ADDRESS: 2201 PANAMA ST

Proposal: Construct fourth floor and roof deck

Review Requested: Review In Concept

Subject: Historic Project Review Application for 2201 Panama St

Proposed Plans

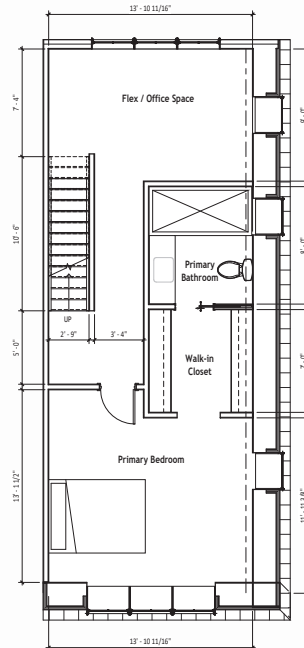
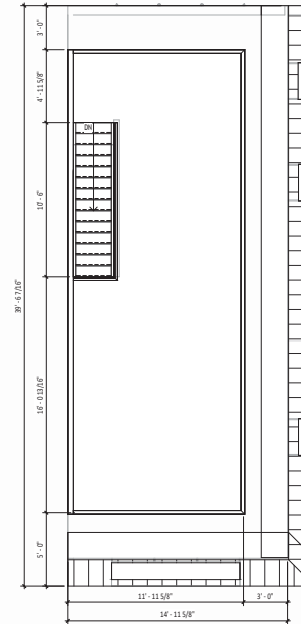
addition, and the placement of the roof deck, should be adjusted to limit the visual impact on adjacent and nearby contributing historic properties.

- *Roofs Guideline I Recommended: Designing rooftop additions, elevator or stair towers, decks or terraces, dormers, or skylights when required by a new or continuing use so that they are inconspicuous and minimally visible on the site and from the public right-of-way and do not damage or obscure character-defining historic features.*
 - o The Roofs Guideline does not apply to this application because the building in question is non-contributing; there are no character-defining features at the building. The visual impact of the proposed addition and deck should be minimized to lessen the impact on contributing buildings in the vicinity.

STAFF RECOMMENDATION: Approval, provided the height and massing of the roof addition and the placement of the roof deck are adjusted to minimize to limit the visual impact on nearby contributing historic properties, with the staff to review details, pursuant to the Roofs Guideline and Standard 9.

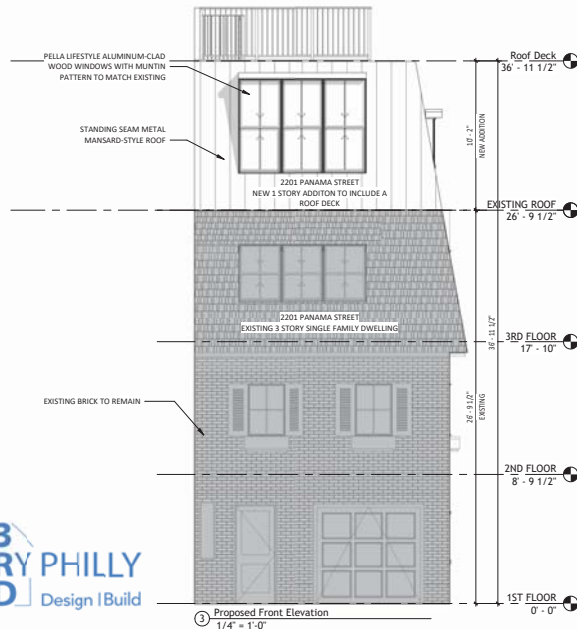
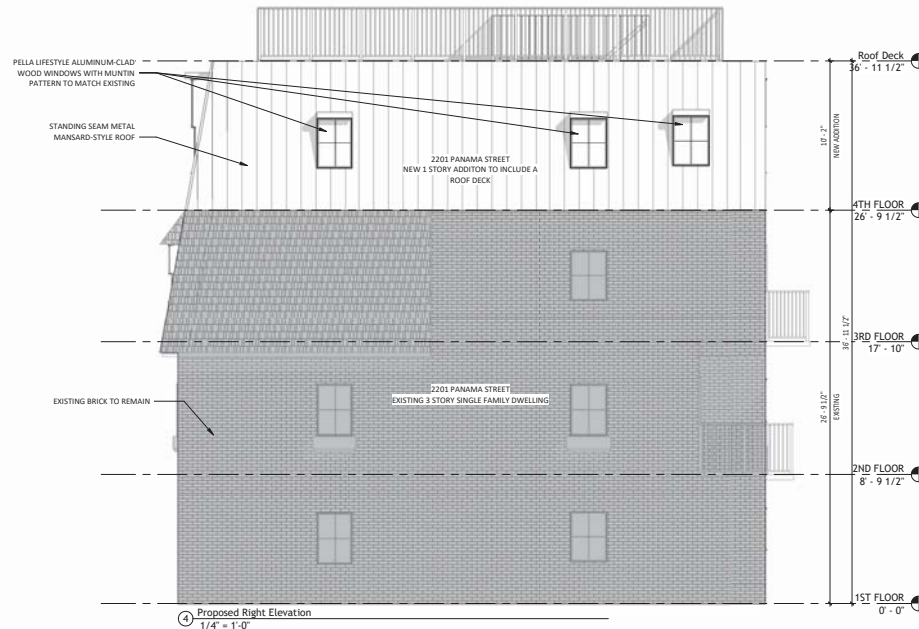
The question in this case is whether the addition and deck will adversely impact the historic district, not the building itself. The proposed addition and roof deck will visually impact the 2200 block of Panama Street and the 300 block of S. 22nd Street. Both blocks are composed of contributing buildings. The building at 2201 Panama Street is more squat than surrounding residential contributing properties. A rooftop addition at 2201 Panama Street will not add enough height to the building to impose upon the surrounding taller historic buildings. This project can be executed without negatively impacting the surrounding historic district buildings, provided the height and massing of the rooftop addition, and the placement of the roof deck is adjusted to limit the visual impact on adjacent and nearby contributing historic properties.

- *Standard 9: New additions, exterior alterations, or related new construction will not destroy historic materials, features, and spatial relationships that characterize the property. The new work shall be differentiated from the old and will be compatible with the historic materials, features, size, scale and proportion, and massing to protect the integrity of the property and its environment.*
 - o The building is not historic, so no historic materials would be destroyed with the construction of the addition and deck. The height and massing of the roof
